Origination Form
Proposed Revisions to a Standard Plans Index

Originator:	Meyer, Ronald	Index Number:	700-120
Date:	6/5/2024 1:55:54 PM	Sheet Number(s):	7, 8, 10, 13, 14
E-mail:	Ronald.Meyer@dot.state.fl.us	Index Title:	ENHANCED HIGHWAY SIGNING ASSEMBLIES

ROADSIDE SIGN ASSEMBLY-4

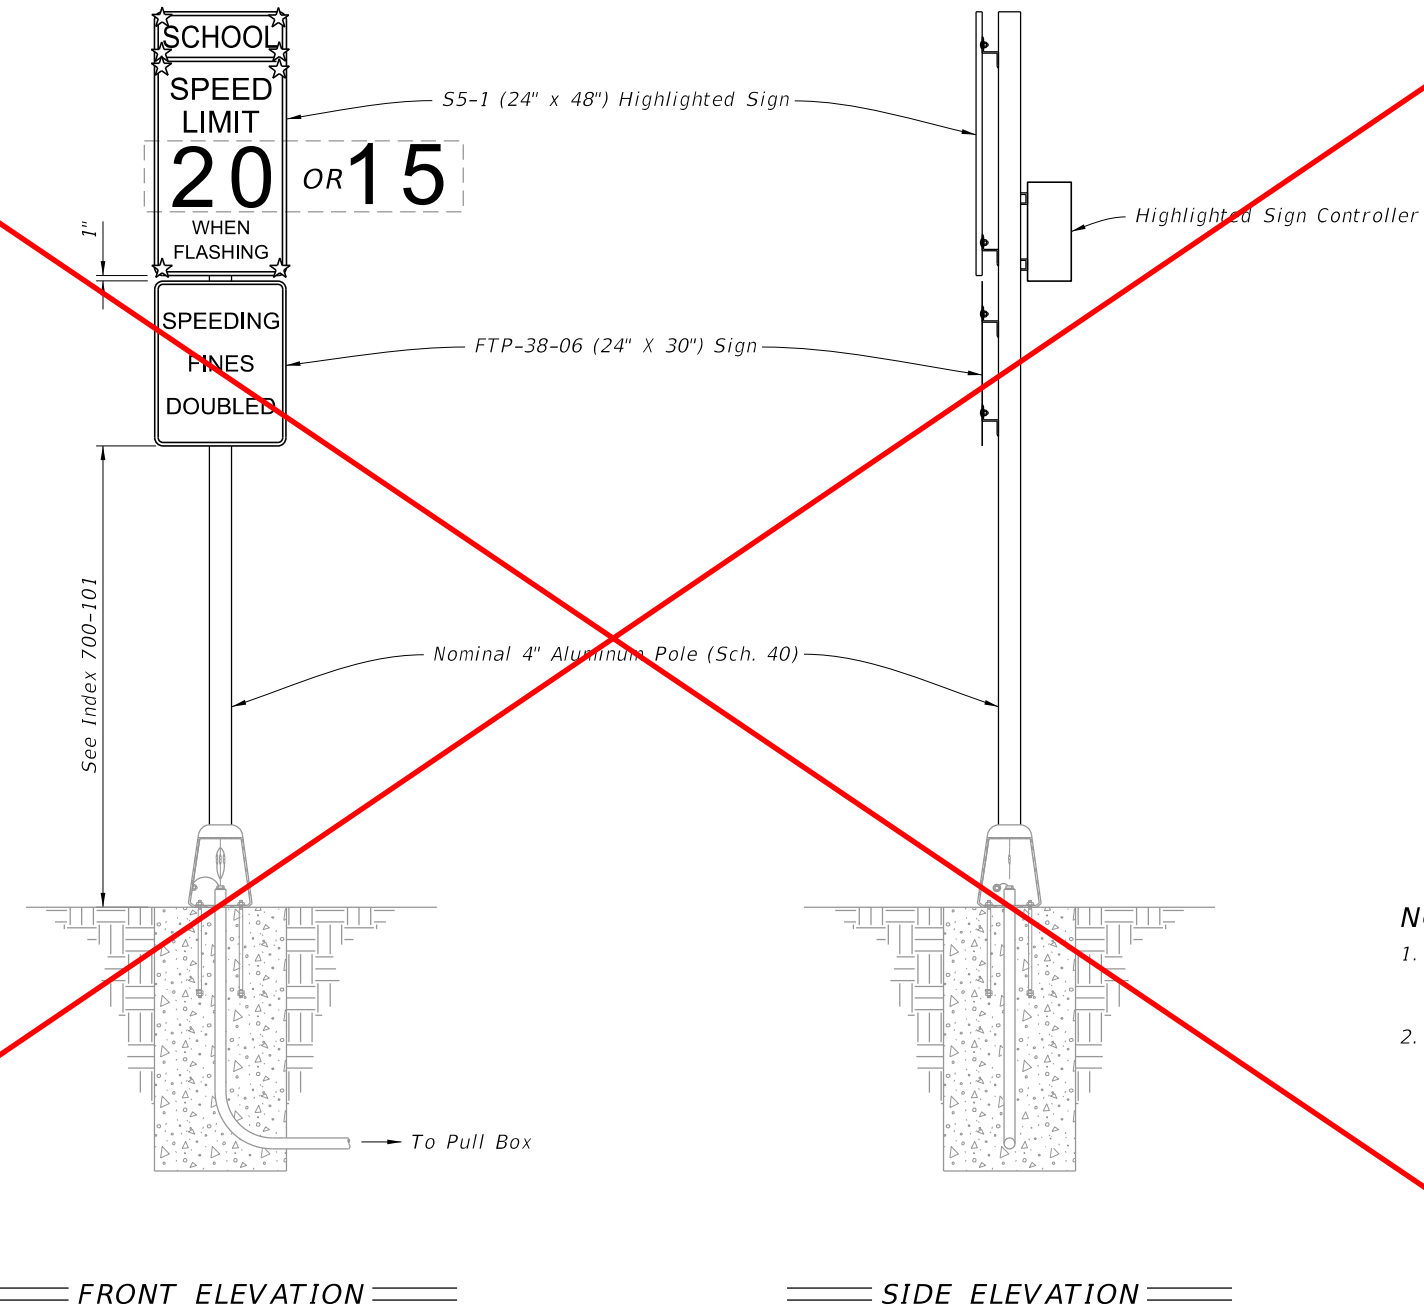
DELETED SHEET:
 The 11th Edition MUTCD, Section 2A.12 (12) states:
 Flashing LED units shall not be used within the legend or border of a
 Speed Limit sign to indicate that the displayed speed limit is in effect.

ROADSIDE SIGN ASSEMBLY-5

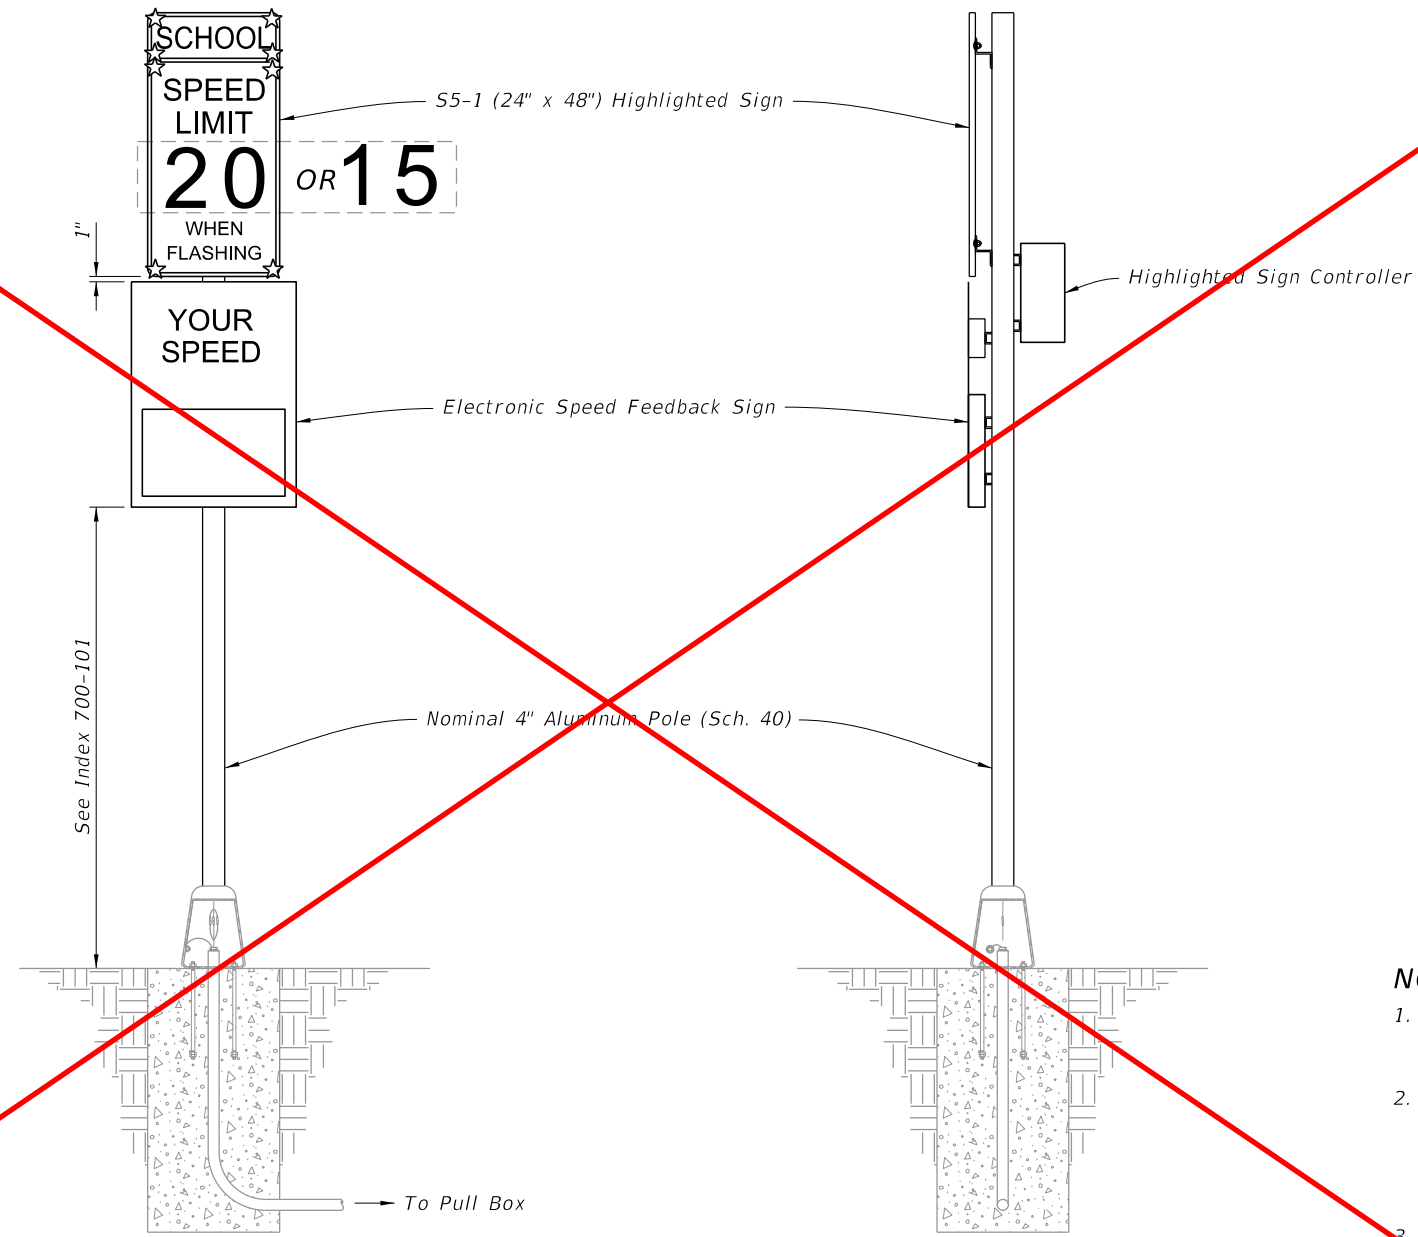
DELETED SHEET:
 The 11th Edition MUTCD, Section 2A.12 (12) states:
 Flashing LED units shall not be used within the legend or border of a
 Speed Limit sign to indicate that the displayed speed limit is in effect.

ROADSIDE SIGN ASSEMBLY-10

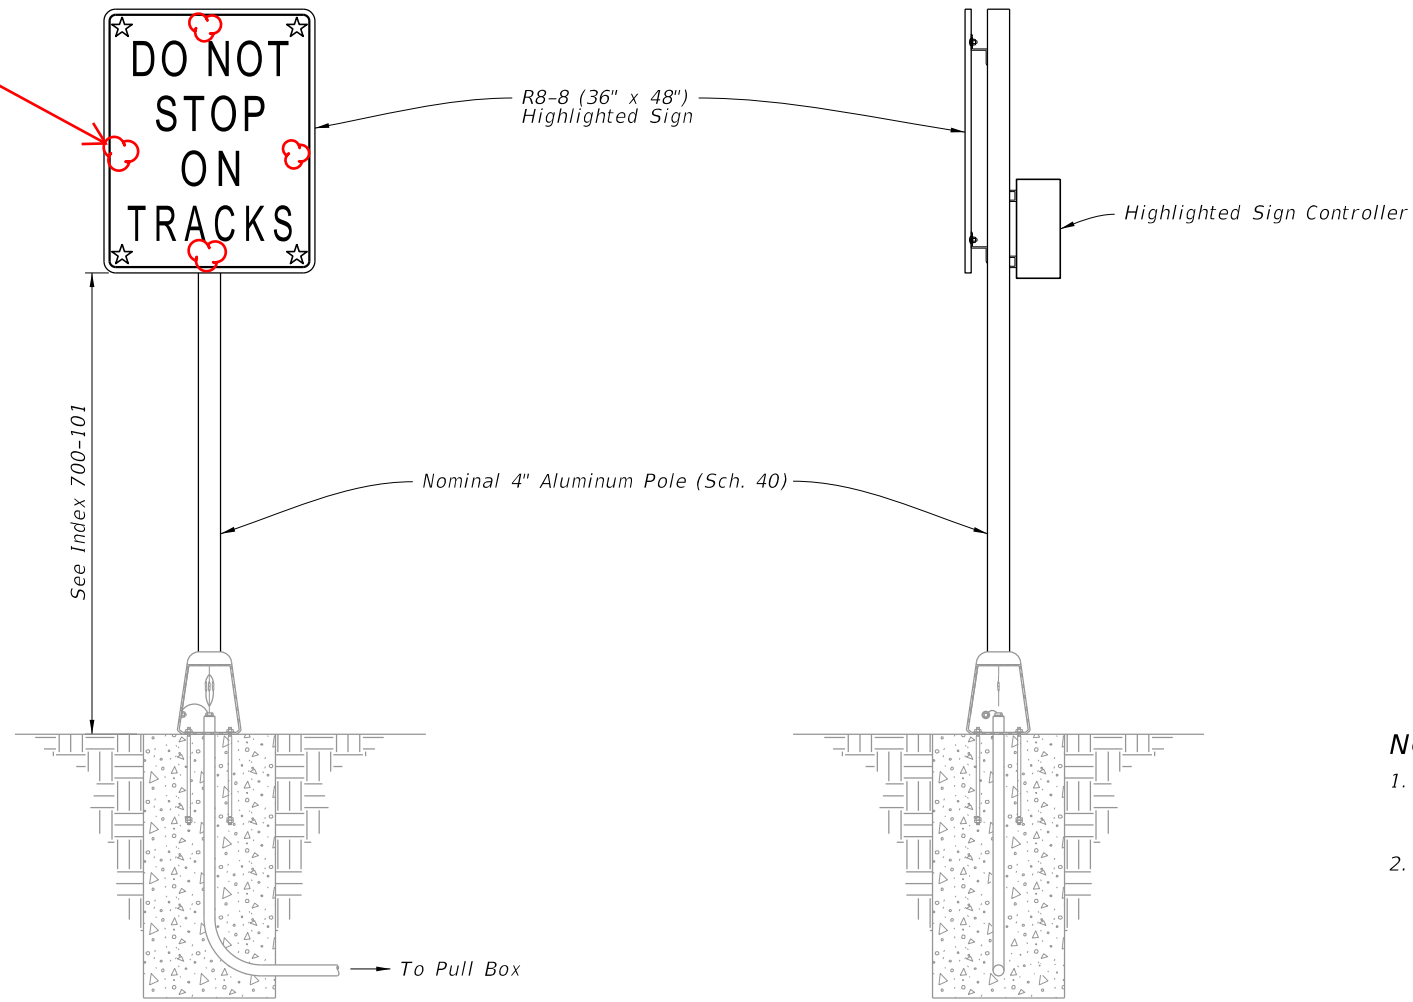
ADDED: LEDs in the middle of each sign edge, for a total of 8 LEDs.

Sheet 10, 13, and 14: Where LED units are used along the edge of a sign, at least one LED unit shall be placed along each edge of the sign, in addition to one LED unit at each corner of the sign, so that the distinct outline of the sign shape is recognized under nighttime viewing conditions. The LED units along each side of the sign shall be spaced approximately equidistantly. For a circular sign shape, the number of LED units shall clearly form the appearance of a circle and not be perceived as some other shape.

ROADSIDE SIGN ASSEMBLY-11

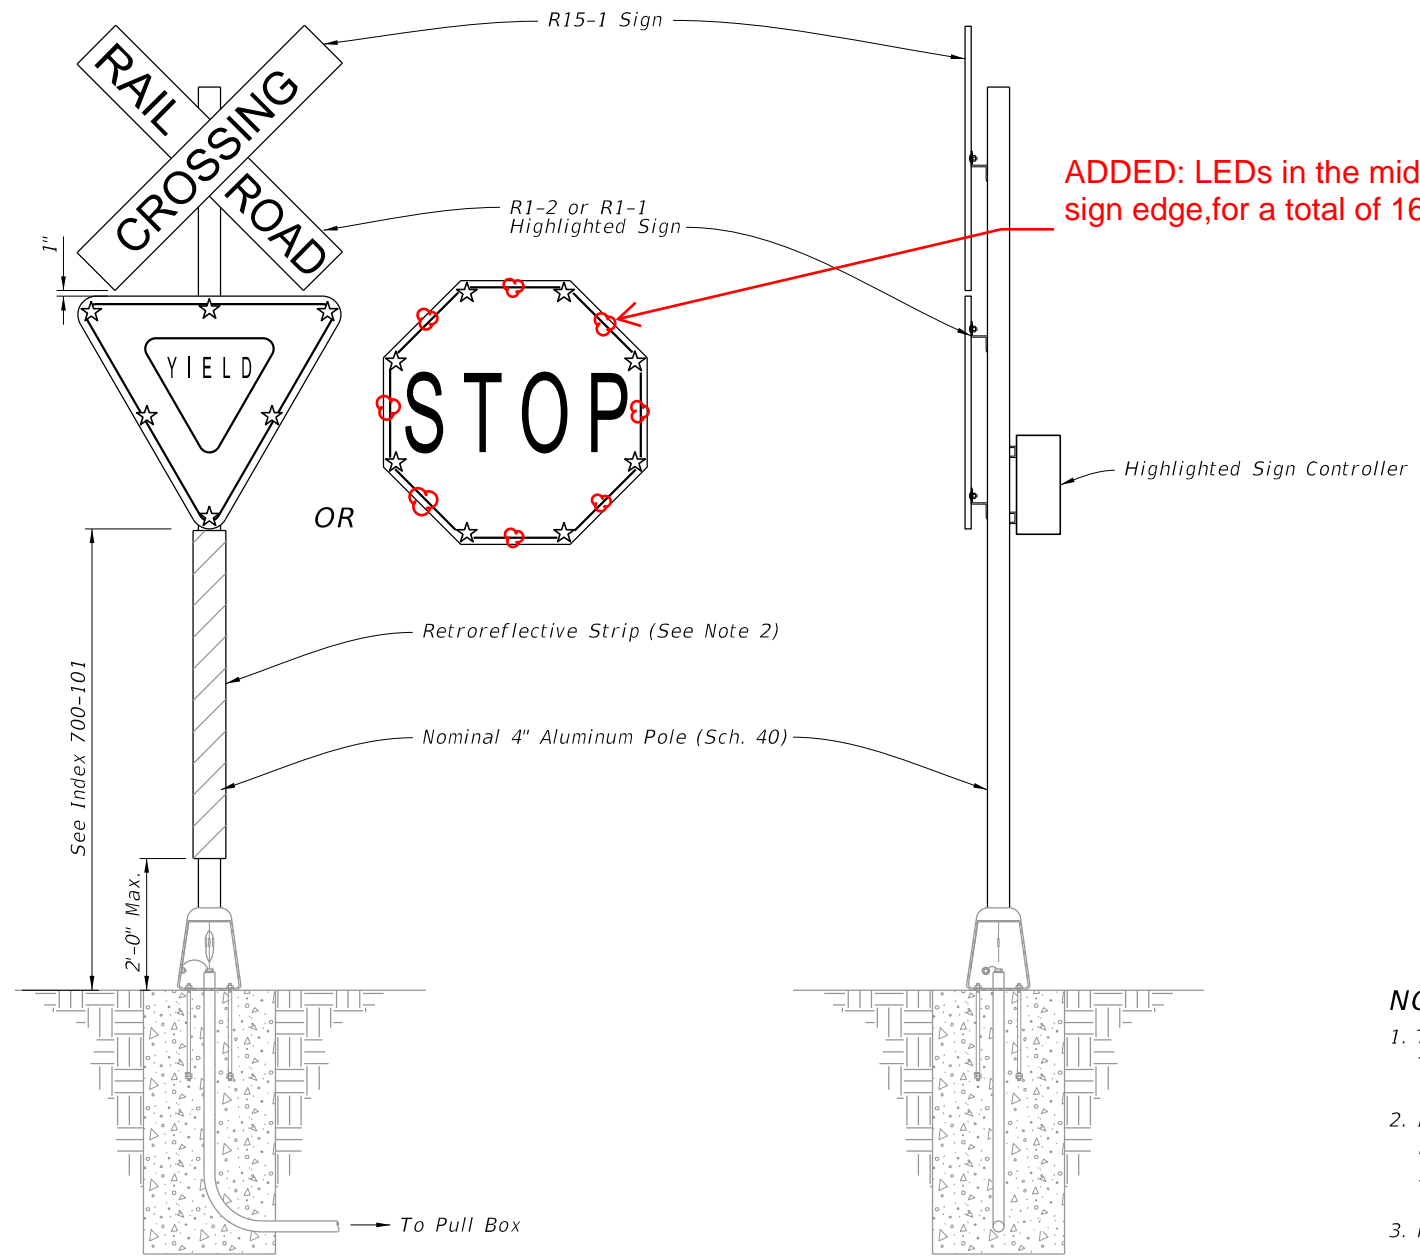
ADDED: LEDs in the middle of each sign edge, for a total of 16 LEDs.

ROADSIDE SIGN ASSEMBLY-8

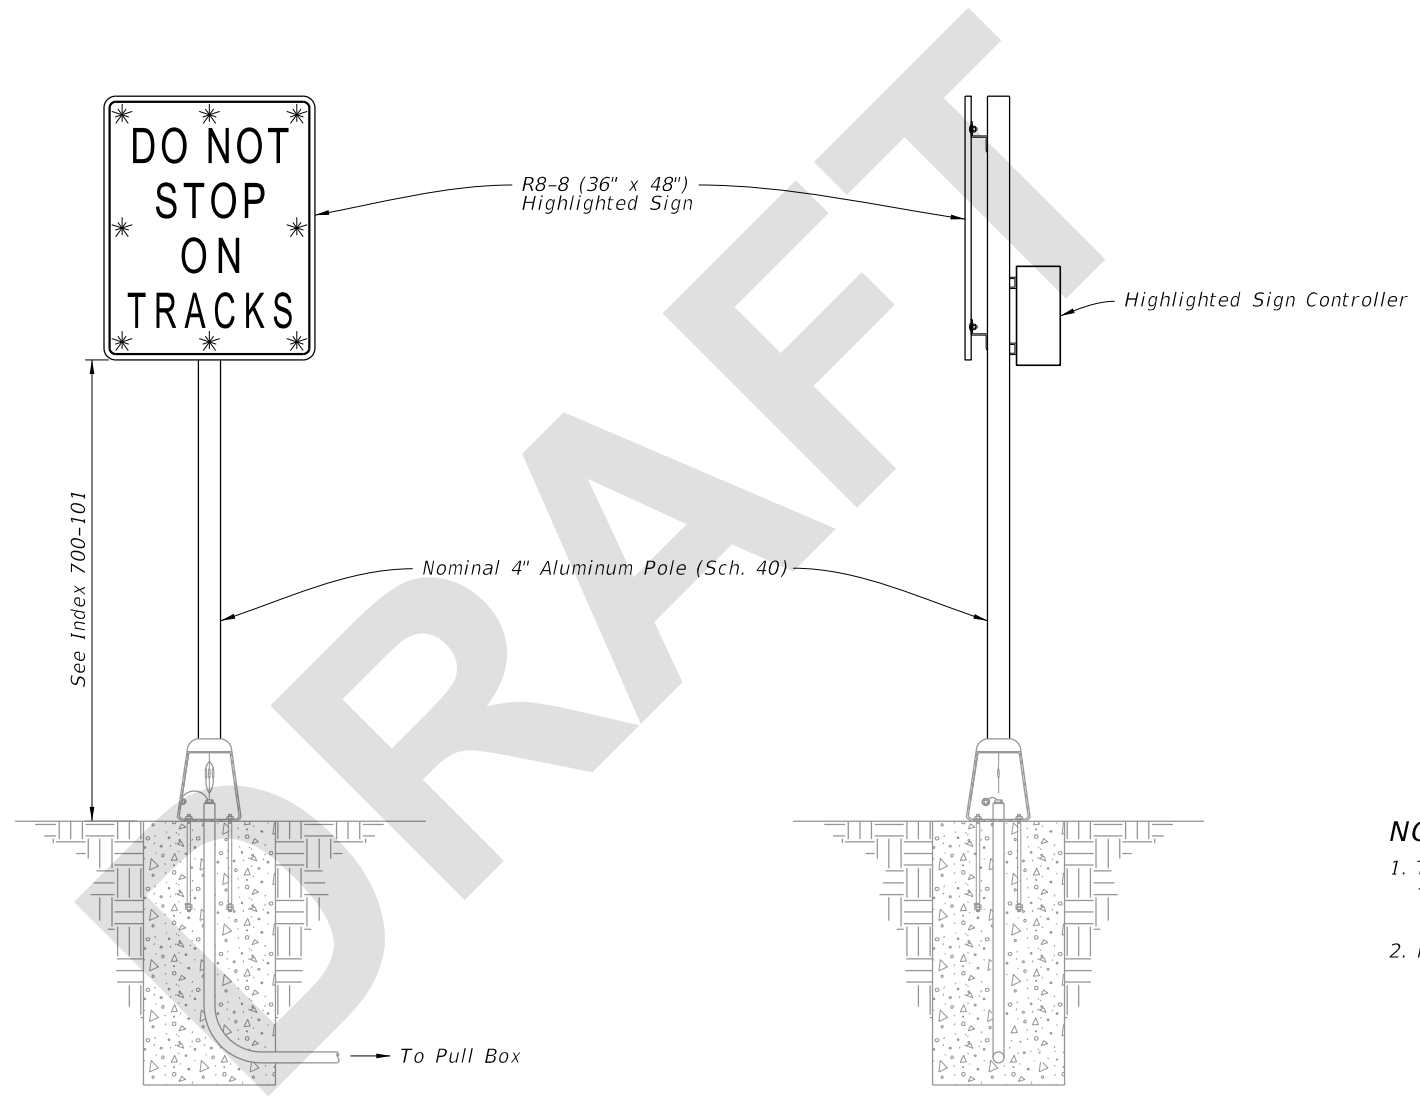
All Sheets: Renumbered Sheets
 Sheets 9-14: Renumbered Roadside Sign Assembly.
 Sheet 7: Deleted Sheet per 11th Edition MUTCD, Section 2A.12.
 Sheet 8: Deleted Sheet per 11th Edition MUTCD, Section 2A.12.
 Sheet 10: Added LEDs in the middle of each sign edge, for a total of 8 LEDs.
 Sheet 13: Added LEDs in the middle of each sign edge, for a total of 8 LEDs.
 Sheet 14: Added LEDs in the middle of each sign edge, for a total of 16 LEDs.
